STAFF RECOMMENDATION

407 South 10th Street

Application: New Construction—Infill and Outbuildings

Description of Project: Application is to construct duplex infill and two outbuildings.

Figure 6: Right side elevation

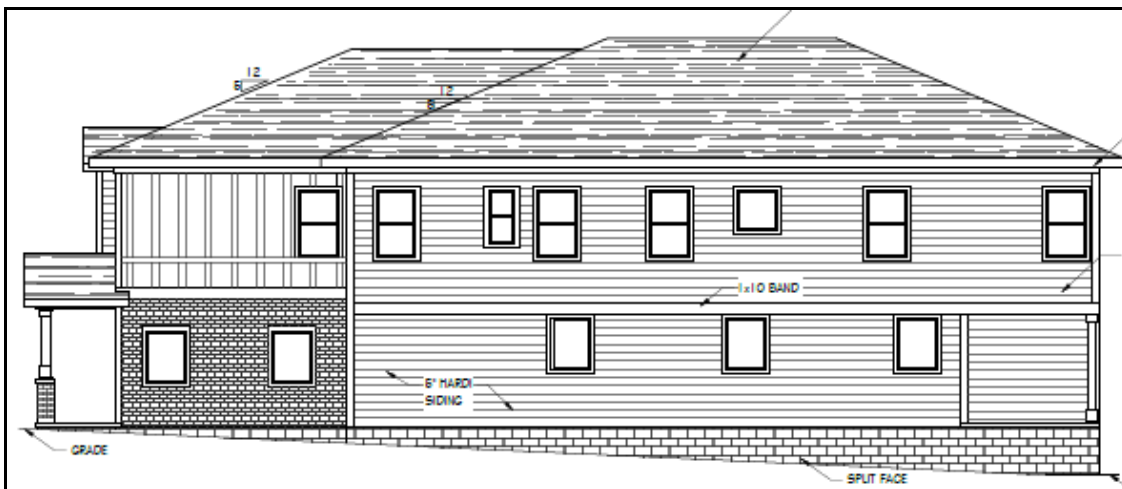
Proportion and Rhythm of Openings: Historically, windows tend to be vertically oriented. While each side elevation has one square window, staff finds that these are appropriate as accents and that generally, the windows are vertically oriented. There are no large expanses of wall space without a window or door opening. Staff finds the project's proportion and rhythm of openings to meet Section II.B.7.

Appurtenances & Utilities: The location of the HVAC and other utilities was not noted. Staff asks that the HVAC be located on the rear façade, or on a side façade beyond the midpoint of the house, and that utility meters be located on the side of the building, within five feet (5') of the front corner or on the rear or rear-side within five feet (5') of the rear corner. Alternative mechanical and utility locations must be approved prior to an administrative sign-off on building permit(s). With this condition, the project meets section II.B.9.

Figure 7: Elevations of proposed outbuildings. Two identical outbuildings are proposed

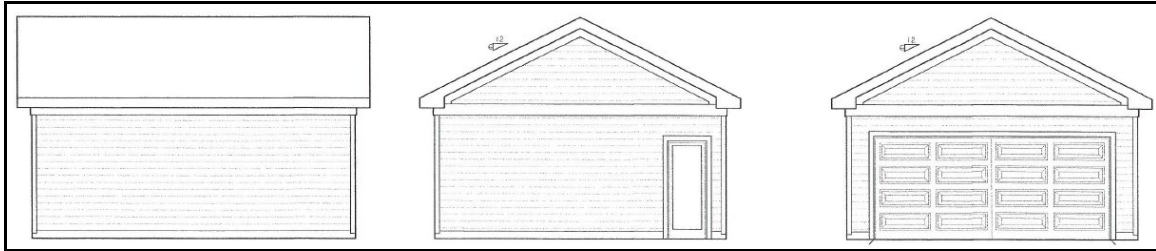
Outbuildings: The applicant is planning two modest one-story outbuildings to serve the two units.

At eleven-thousand, three-hundred square feet (11,300 sq ft), the lot is large enough for a one thousand square foot (1,000 sq ft) outbuilding. Each of the two proposed garages measure four-hundred-forty (440) square feet, for a total of eight-hundred-eighty (880) square feet of outbuilding foot print.

The two garages meet the setback requirements. There is about eight feet (8') of space between the garages.

Lap siding is indicated. It should be smooth with a maximum five inch (5”) reveal. With the staff’s final approval of the roof shingle color, the trim material and the pedestrian and garage doors, staff finds that the known materials meet Section II.B.8. of the design guidelines.

Design Standards: The outbuildings have a simple design. The roof form, detailing, and building form do not contrast greatly with the primary structure. The outbuildings will be located at the rear of the lot in a minimally visible location. Staff finds that the design of the outbuildings meets Sections II.B.8 of the design guidelines.
